IFC Design Analysis

WWYK190068 Repair Fire Suppression System, Maint Hangar B2280

Project Number: WWYK190068
Work Order: 20435 - Amend

Tinker Air Force Base, Oklahoma
April 3, 2025

SHEET TITLE
PROJECT DRAWING INDEX AND VICINITY MAP

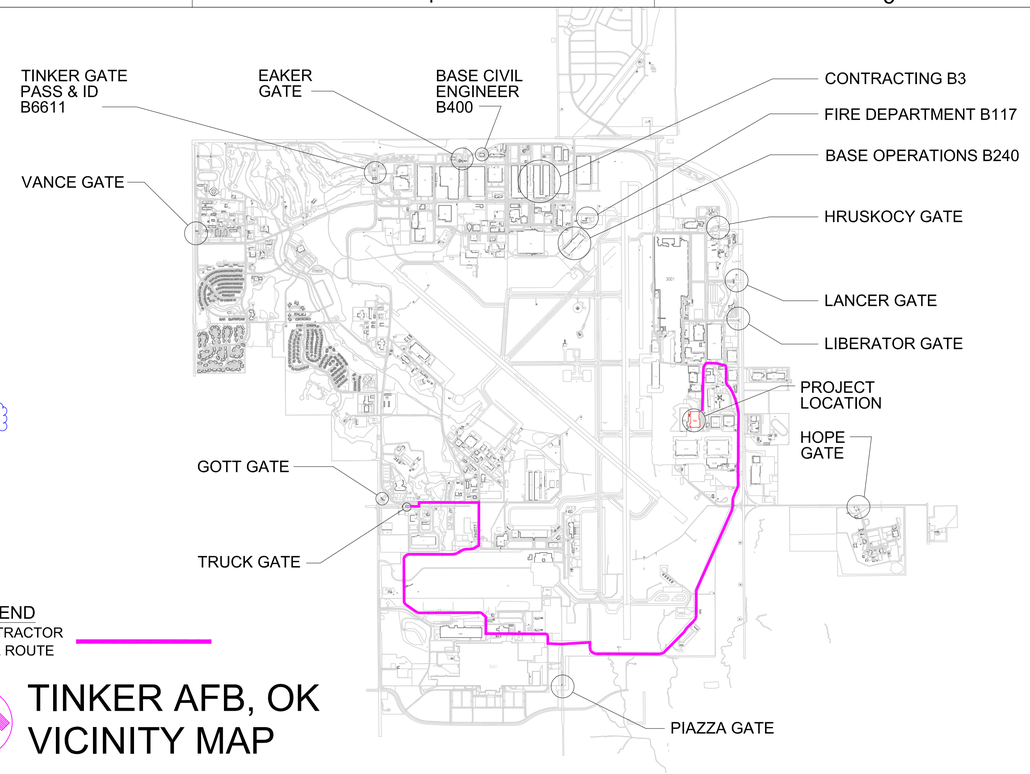
Set has not been bookmarked

Provide sheet bookmarks

COMMENT FOR MODEL MANAGER/PM
THIS IS A DUST OFF PROJECT SO CONFIRM IF SHEET ORDER NEEDS TO/SHOULD BE UPDATED TO THE TYPICAL USACE SHEET ORDER REQUIREMENTS

SHEET TITLE
GENERAL PHASING PLAN

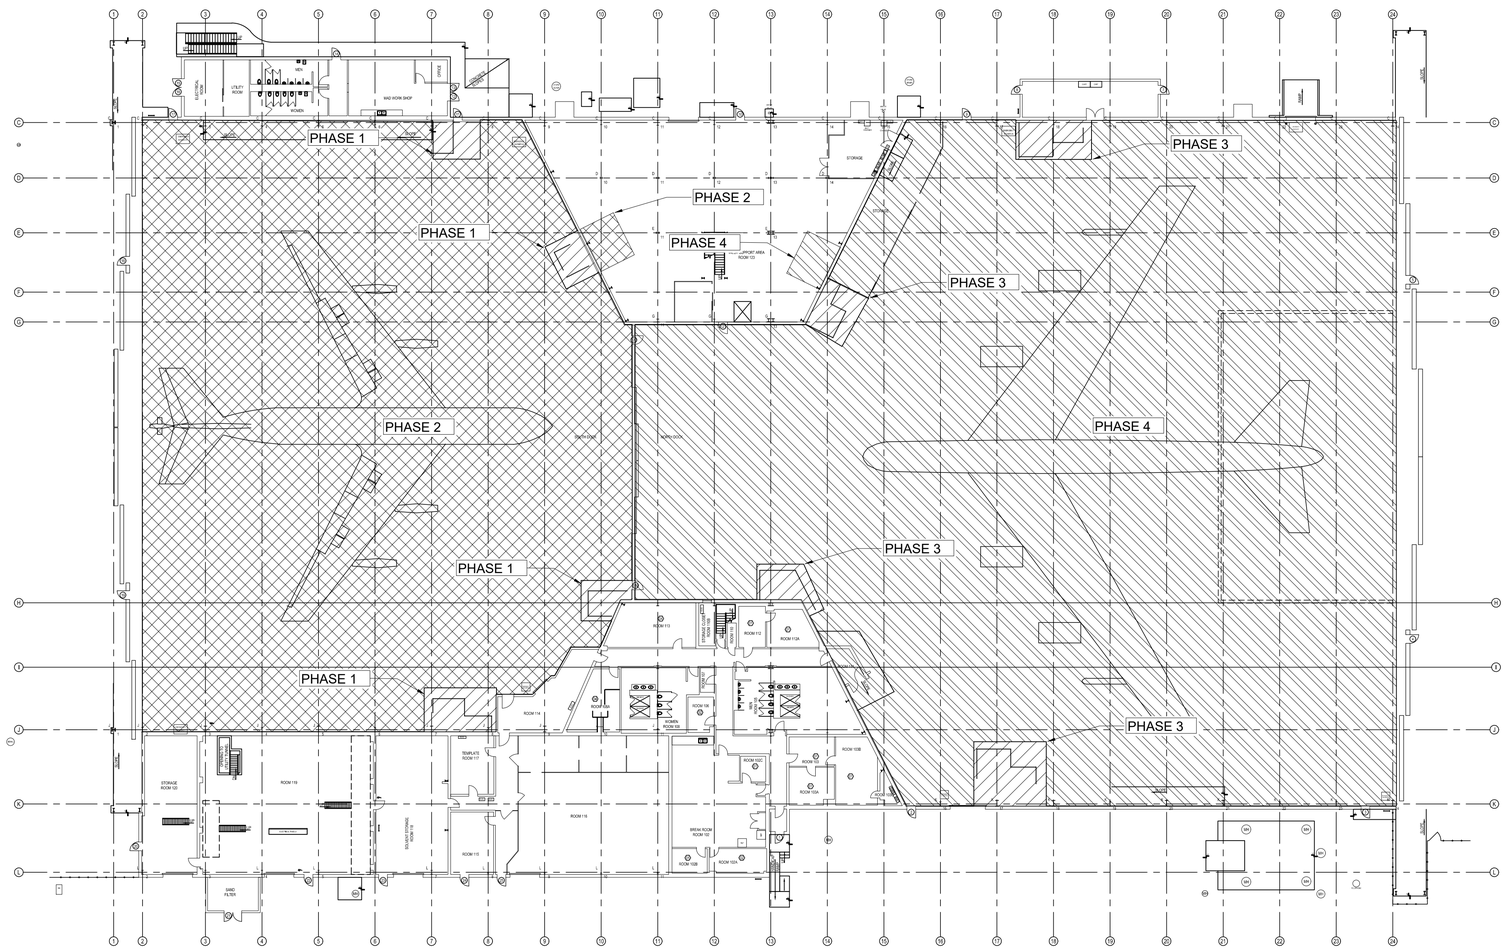
Has the phasing plan been updated to reflect the demolition items that will fall under a separate AFCEC contract?

Should we have a legend for the phase hashing?

Update

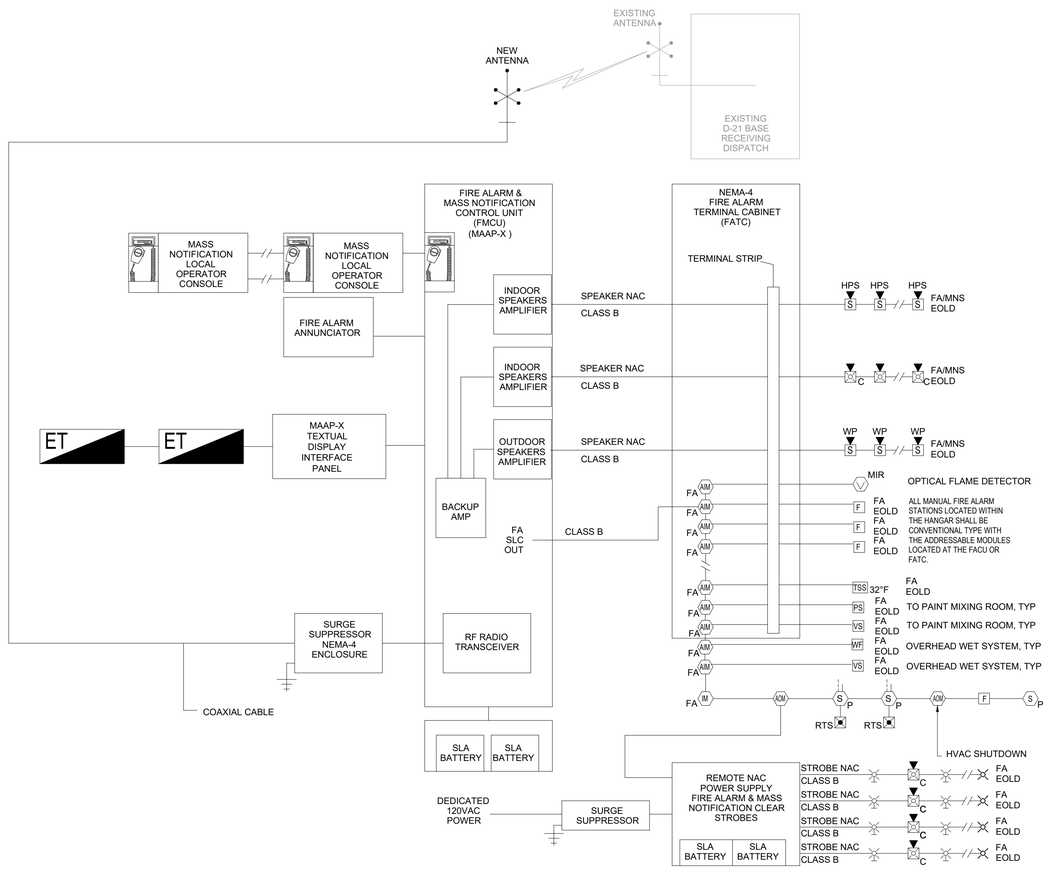
Title?

1 FX101 FIRE SUPPRESSION FIRST FLOOR PLAN - AREA A - NEW WORK

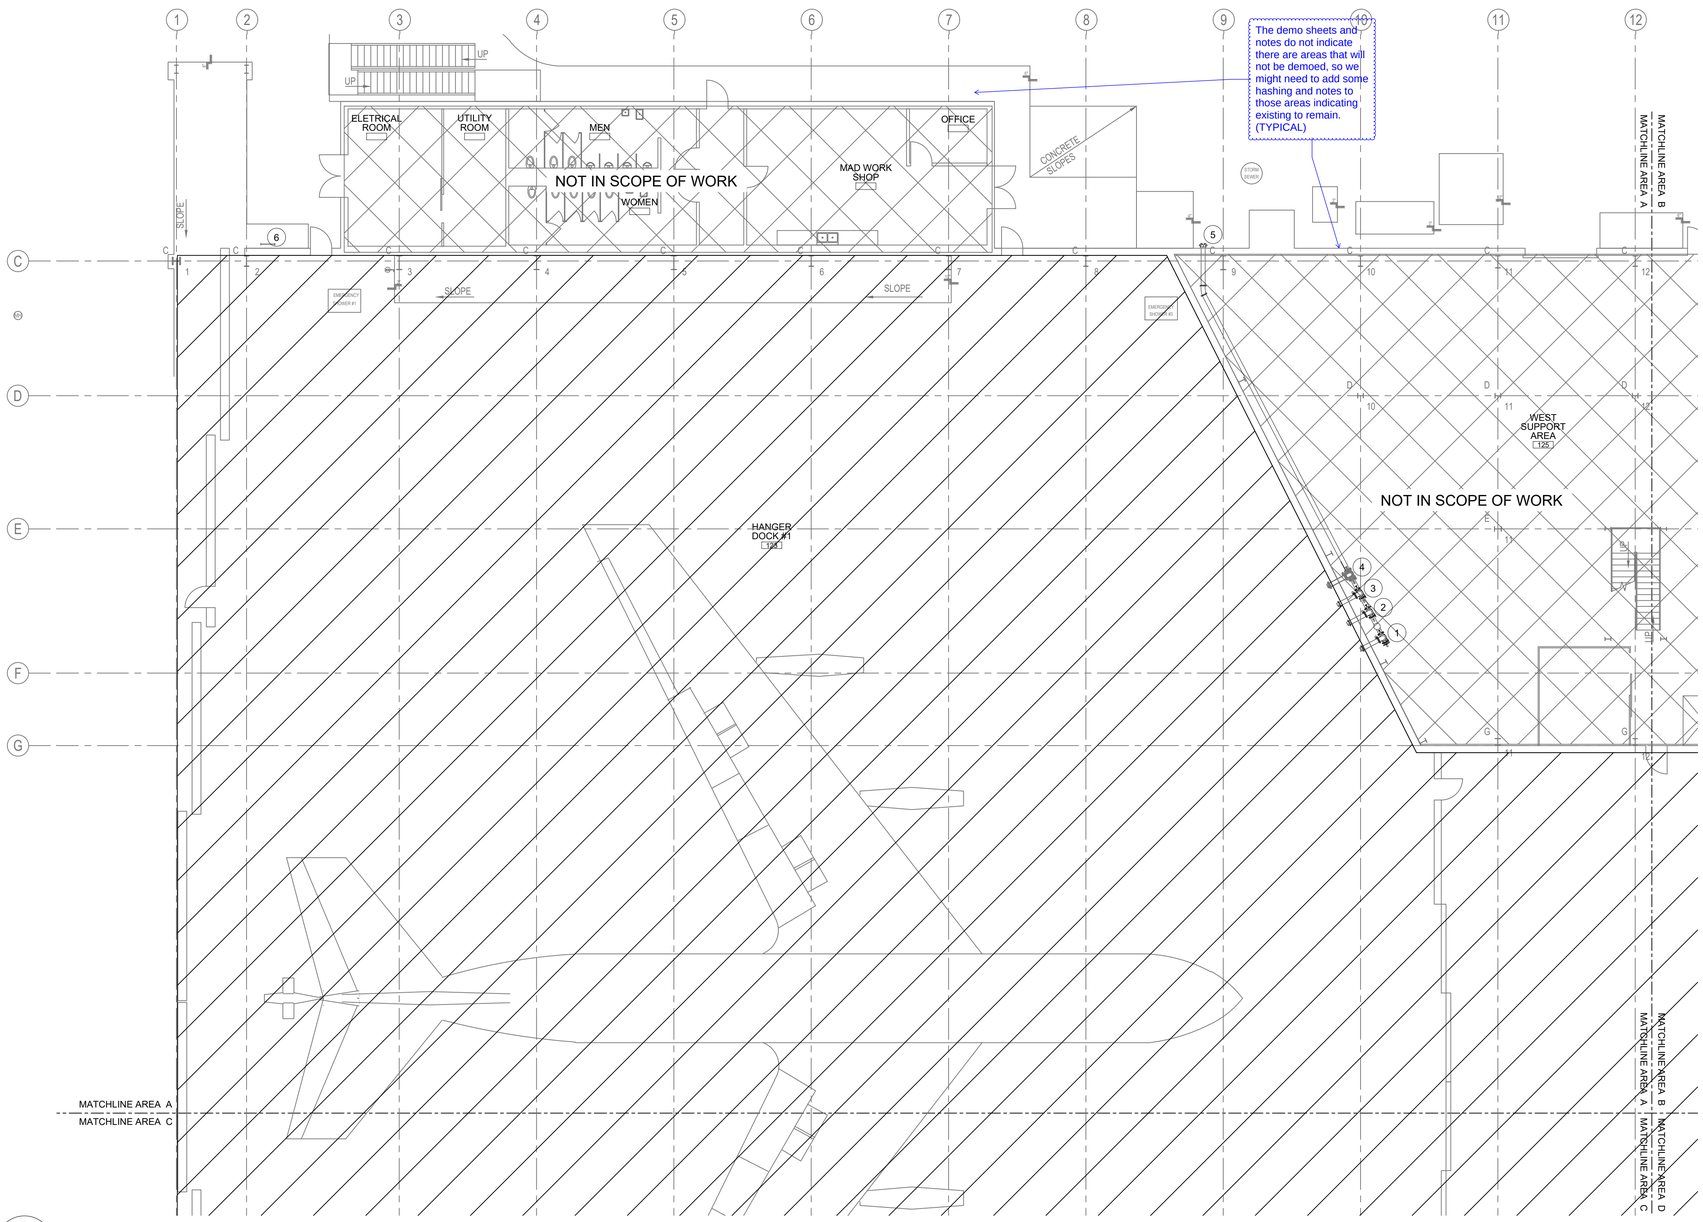
Is this mentioned in the demo sheets or general notes?

The demo sheets and notes do not indicate there are areas that will not be demoed, so we might need to add some hashing and notes to those areas indicating existing to remain. (TYPICAL)

1
FX104
FIRE SUPPRESSION FIRST FLOOR PLAN - AREA D - NEW WORK
SCALE: 3/32" = 1'-0"

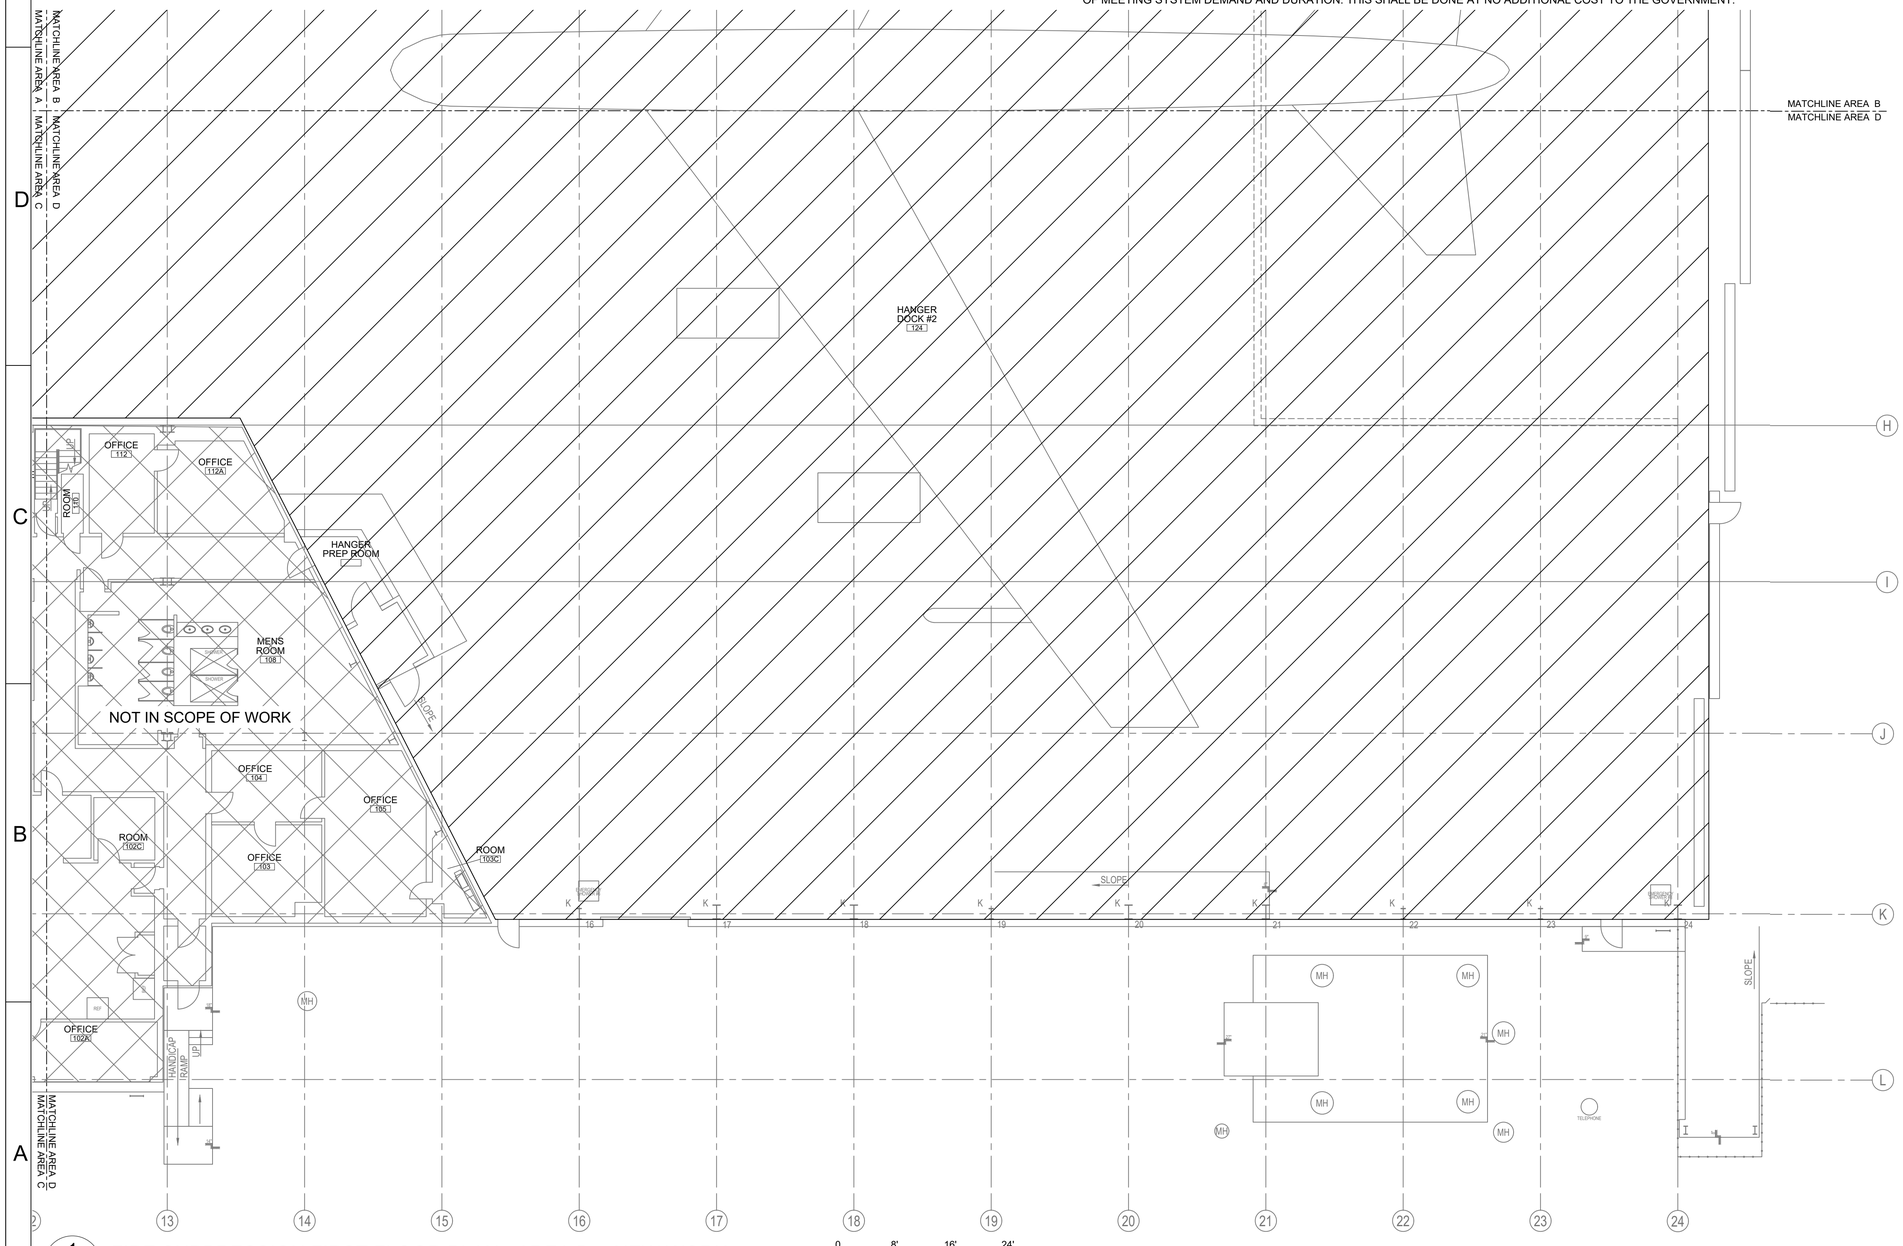
No sheets for Mezz and Floors 2 & 3, even if to sow it not in scope of work?

1 A-401 ARCHITECTURAL ENLARGED FLOOR PLAN - DEMOLITION

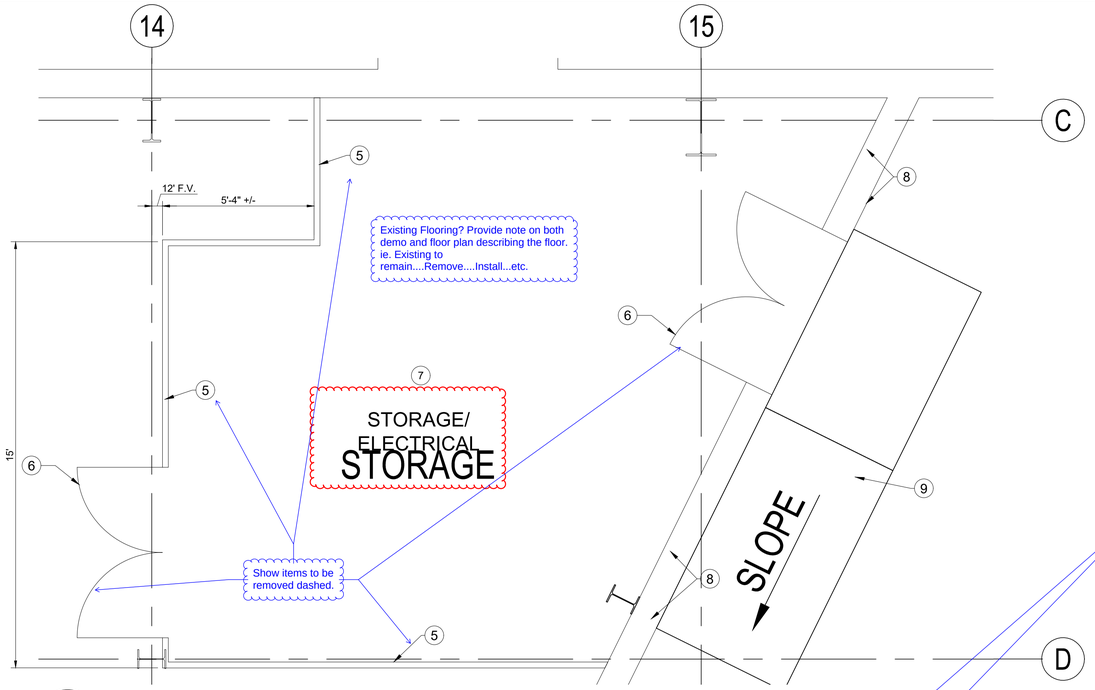
Verify 12" Coordinate with structural
